To: **Planning Commission**
From: **Melissa Sonnek, City Planner**
Date: **August 18, 2020**

Conditional Use Permit, Site Plan, Rezoning, and Plat for 1571 Robert St.

Case 20-09 – Plan Review for Town Center One Redevelopment

Site Access – Wentworth Avenue

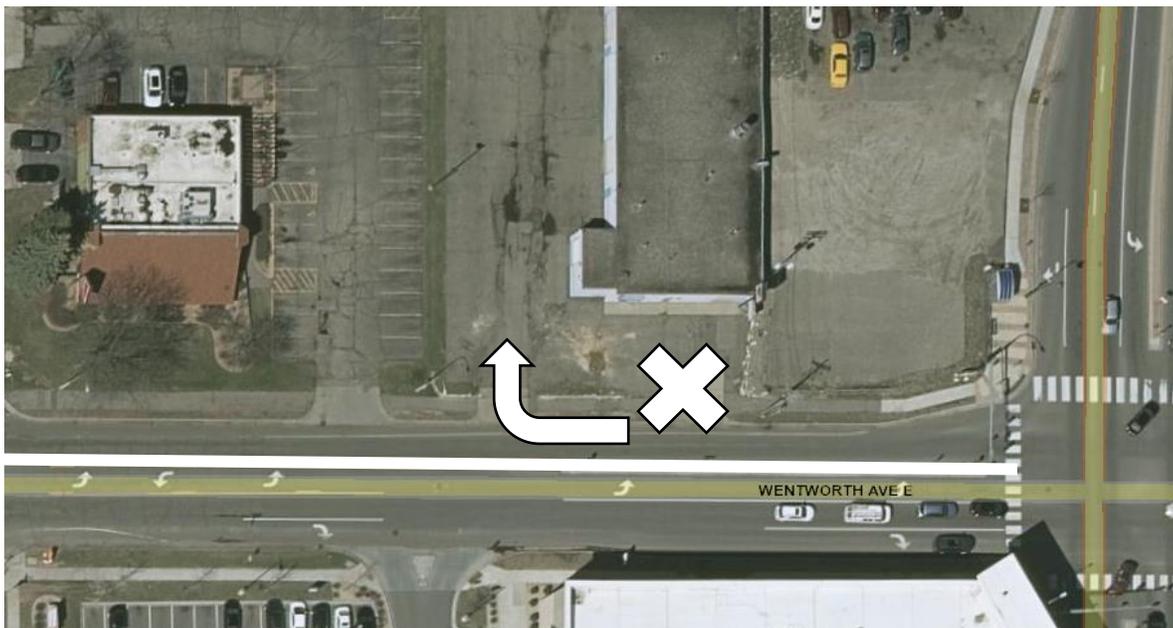
The Wentworth Avenue access to the site was reviewed by Dakota County during their County Plat Commission meeting on August 5th. Due to the conflicts currently happening at the site, Dakota County is requiring that, in order to maintain the western Wentworth access to the site, the center median would have to be extended west to Livingston Avenue.

The applicant will be work with City Staff and Dakota County to add the median extension to the 2021 Wentworth Avenue road overlay project. Staff is recommending as a condition of approval, that the applicant adhere to the items listed in the Dakota County Plat Commission Memo dated August 7, 2020.

Site Access – Robert Street

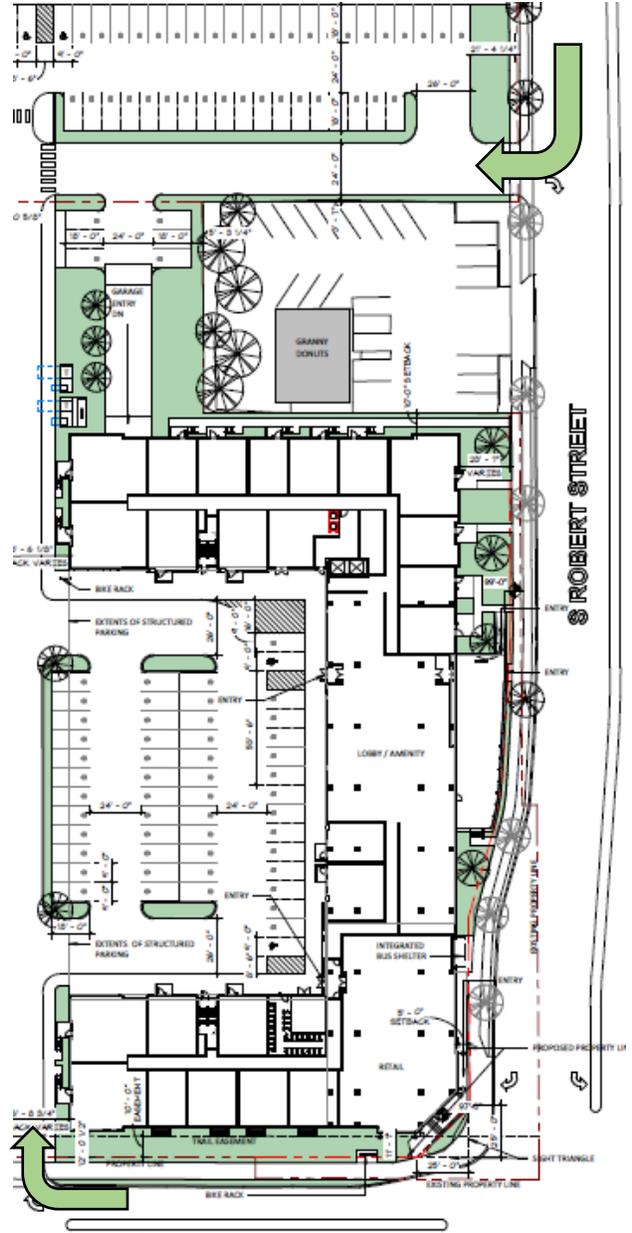
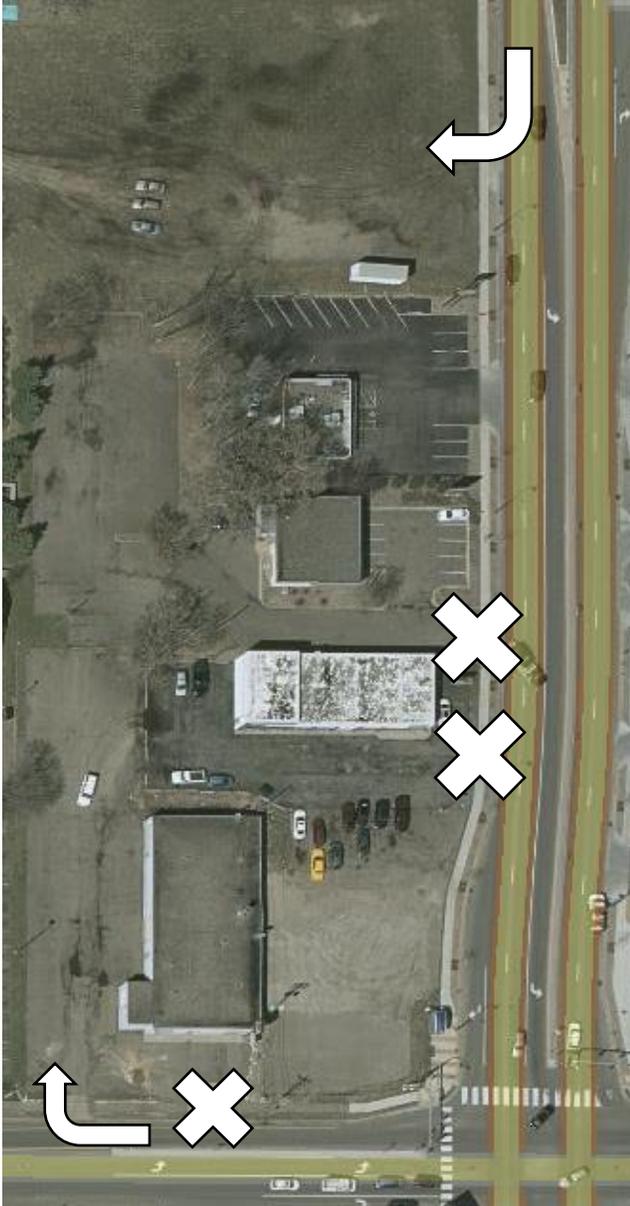
The site as it exists today, has several right in and right out curb cuts onto Robert Street. As with many state and county roads, when a site redevelops, multiple accesses are eliminated and one access point is allowed to remain. Since Granny Donuts is not included in the redevelopment proposal, their existing access will remain unchanged. However, the two curb cuts on the southern leg, will be removed and the northern most access (Blockbuster entrance) will remain.

Site Access – Livingston Avenue

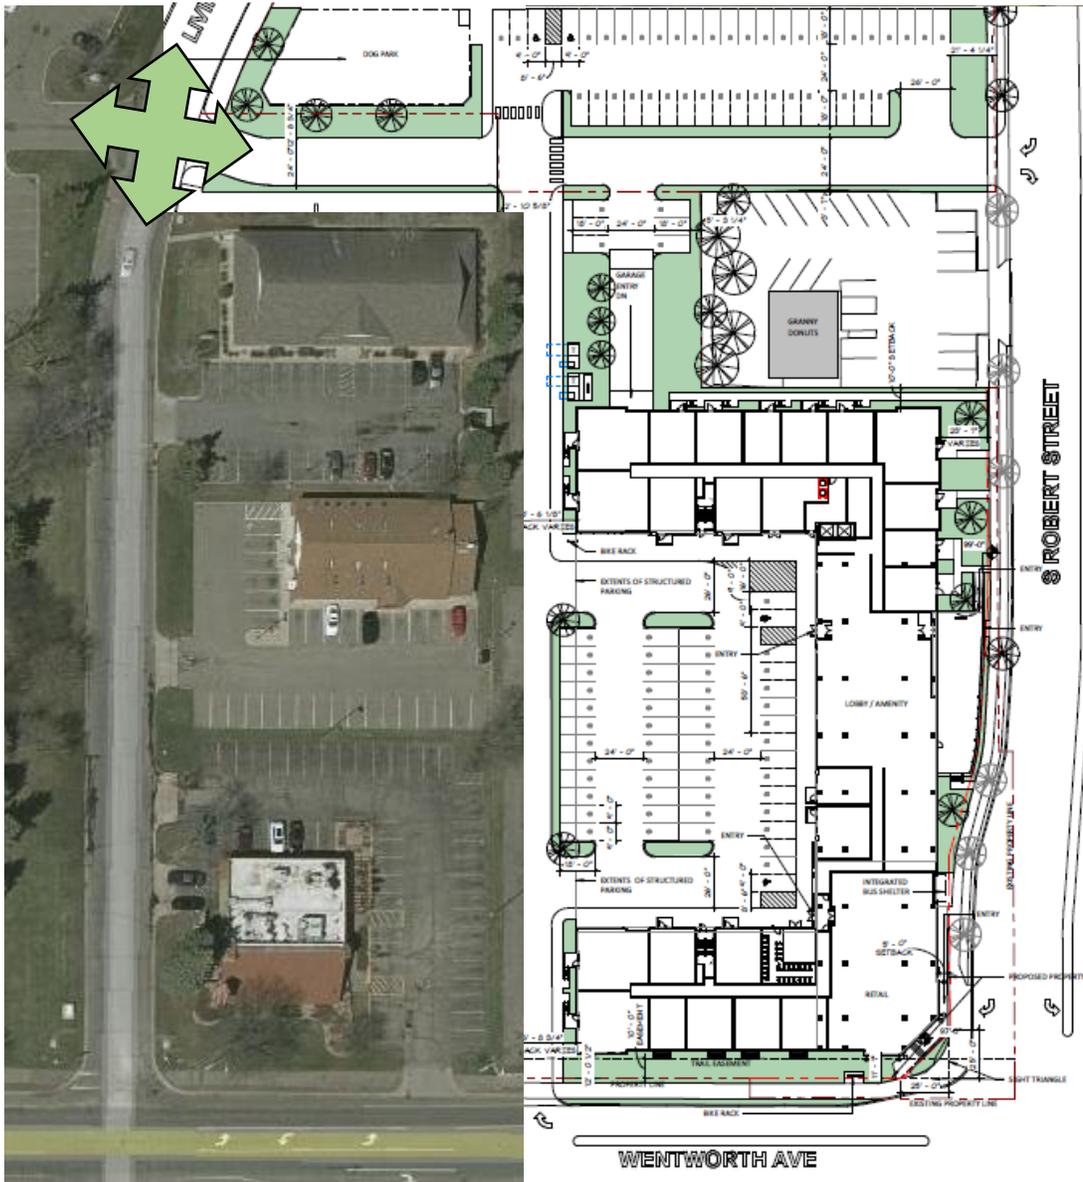
The site will have a full access (all turning movements) on and off of Livingston Avenue on the northwestern corner of the site. This access will line up nicely with the access to the multi-tenant office building to the west as shown in the image below.
